# ***3 Volt Intel<sup>®</sup> Advanced+ Boot Block Flash Memory***

***28F800C3, 28F160C3, 28F320C3, 28F640C3***

***Specification Update***

Order Number: 297938-014

## 2. 28F320C3xC Reset Failure

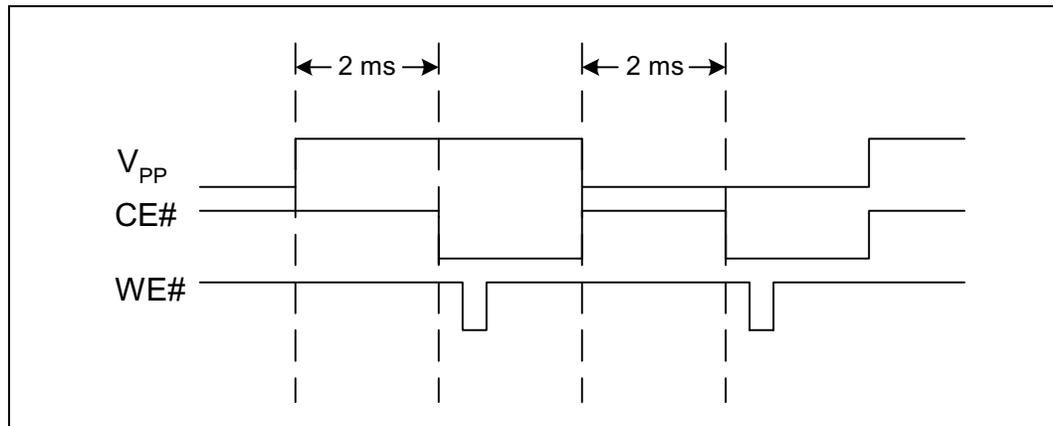
**Problem:** The 0.18 $\mu$ m 28F320C3xC devices can unintentionally reset under certain conditions where  $V_{pp}$  toggles.

**Implication:** When the reset occurs, any command being executed is interrupted and the flash switches to read array mode.

**Workaround:** There are four workarounds for this erratum:

- 1) Tie  $V_{pp}$  to  $V_{CC}$ ;
- 2) If the third and fourth digits on the top side FPO mark (third line) is equal or greater than “23”, then  $V_{CC}$  may be set from 2.7v to 3.3v.  $V_{CC}$  must not exceed 3.3v
- 3) Set  $V_{pp}$  to a static high or static low level as shown here; and

4) Wait 2 ms after a  $V_{PP}$  transition to access the flash device, as shown here.

Figure 1. Workaround Placement

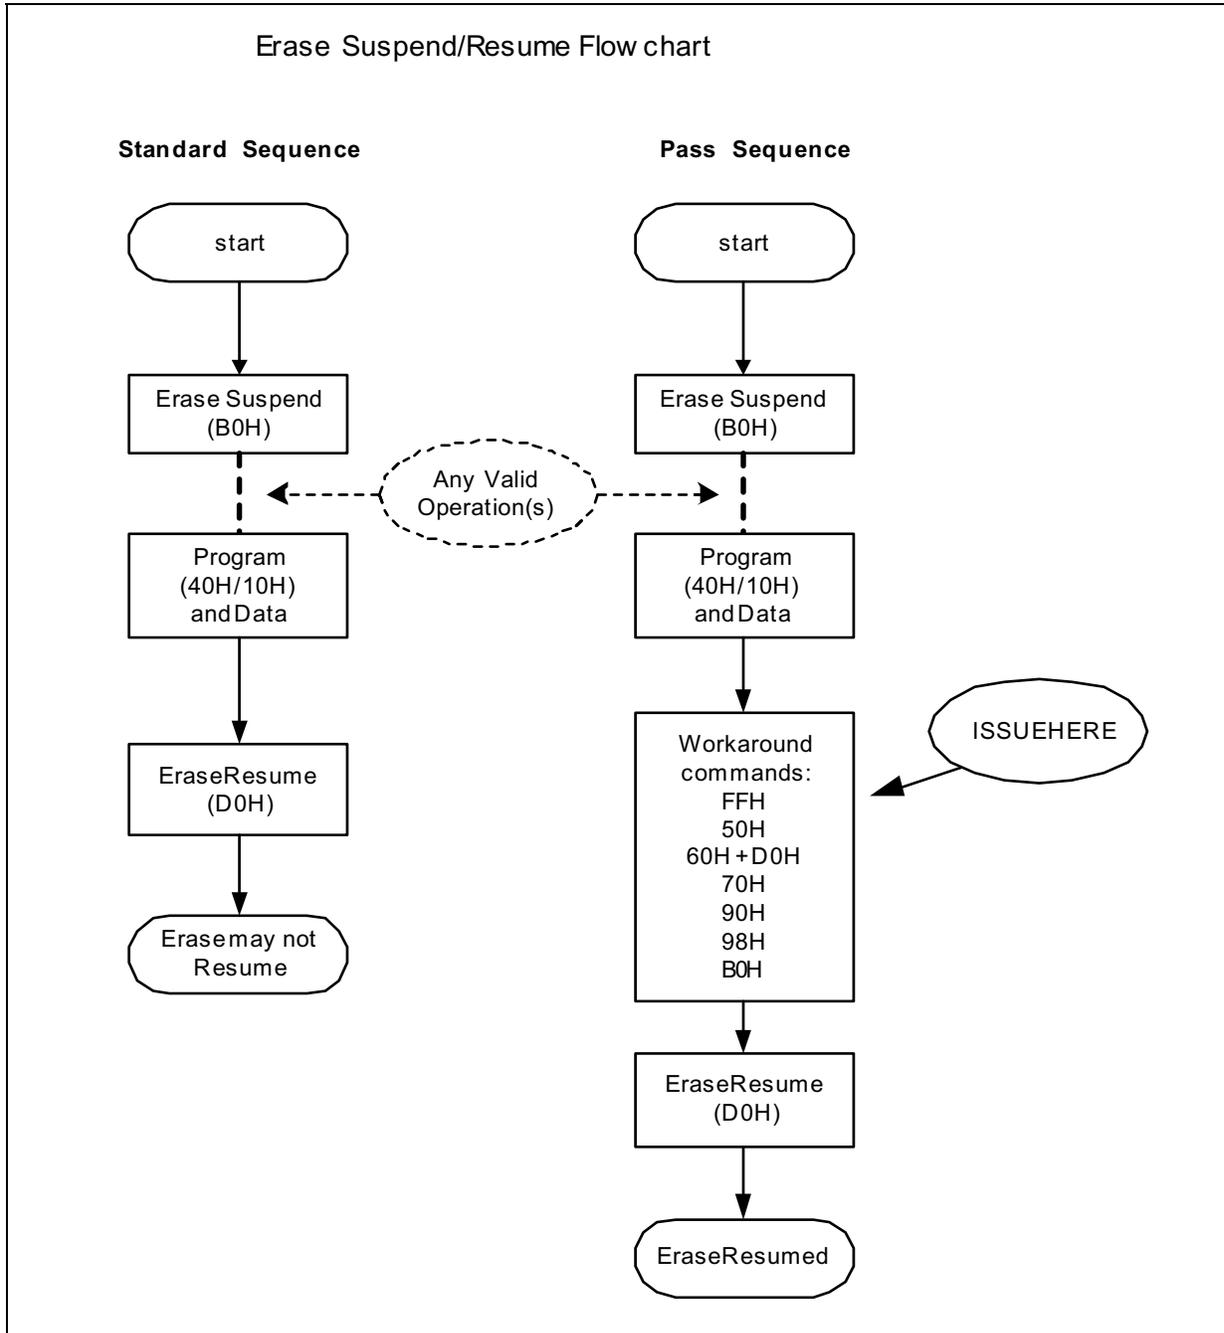
**Problem:** On the 0.18µm 28F160C3xC devices, a design anomaly was discovered. During an Erase-Suspend operation, if the Program (40H/10H) sequence is executed, under limited conditions the proceeding Erase Resume command (D0H) may not actually resume the device. No customers have reported failures in product applications. Customers who use any version of FDI (Intel Flash Data Integrator) software will not see this issue. If the Read Array command is issued prior to the Erase Resume command, users will not see the issue (typical in XIP applications).

**Implication:** The Resume Command (D0H) may be ignored by the device and will not correctly resume. The device will appear to remain in suspend (via status register). After a reset of the flash device the status register will clear. This failure has been recreated in a lab environment only.

1. If FDI (Intel Flash Data Integrator) software is used, users will not see the issue.
2. During an Erase-Suspend (B0H), user must issue any of the following commands after issuing the Program (40H/10H) and data sequence but before issuing the Erase-Resume (D0H) command.

## 5. 28F160C3xC and 28F640C3xC Lock/Unlock/Lock-Down Operation

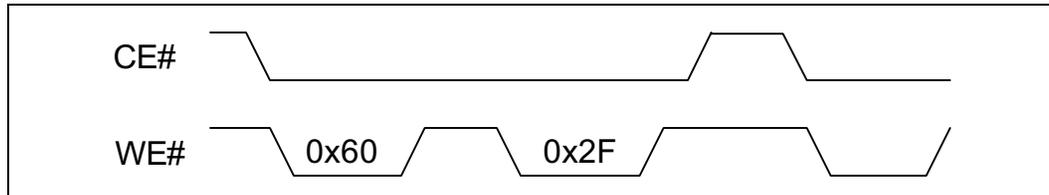
**Problem:** On the 16Mb and 64Mb 0.18 $\mu$ m devices, if CE# is deasserted after any block lock operation and before the next write sequence, the part may perform the same operation on additional blocks. (See waveform below.)

**Implication:** When CE# is deasserted after performing a block lock operation to a specific block and prior to the next write sequence, other blocks may perform the same operation.

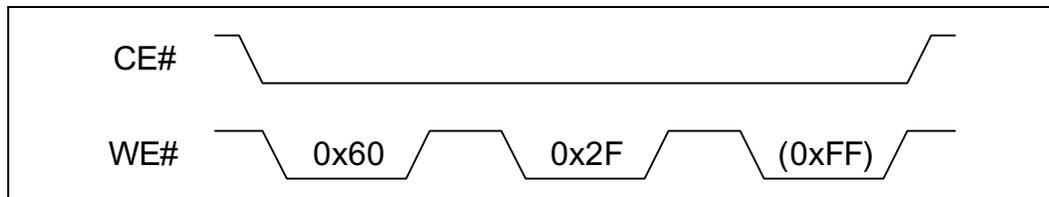
**Workaround:** Depending on software implementation, systems may already be effectively managing this erratum. There is currently a workaround for this erratum:

Immediately after performing a block lock, unlock, or lock-down operation, perform a valid write sequence before chip enable (CE#) is deasserted.

For example, one possible solution is shown below:

- 1) Assert CE# and toggle WE# to write the block lock setup command (0x60).
- 2) Toggle WE# a second time to write the confirm command (lock = 0x01; unlock = 0xD0; lock-down = 0x2F).
- 3) Toggle WE# a third time (ex: 0xFF- Read Array) before CE# is deasserted. (See waveform below.) Any other valid write sequence will also work (i.e., 0x90 - Read Configuration, 0x40 - Program, 0x20 - Erase).
